November 1, 2006

RE: Pennsylvania Gaming Control Board Riverwalk Casino TIS Review PennDOT Agreement E00229, Work Order 14 EK Project No. 040015.038

Figure 3. Columbus Blvd. at Noble Street, Facing North

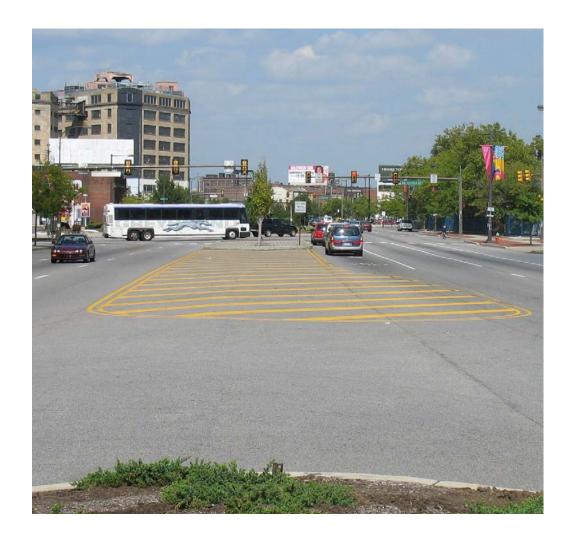
- 8. Figure 3 shows the Noble Street median break in the foreground, the striped median in the middle, and the curbed median near the turning bus.
- 9. The planned northbound right-turn lane at the Noble Street entrance will require removal of on-street parking and utility relocation (fire hydrant, light poles, and underground utilities). Figure 4 shows the approximate location of the site drive.
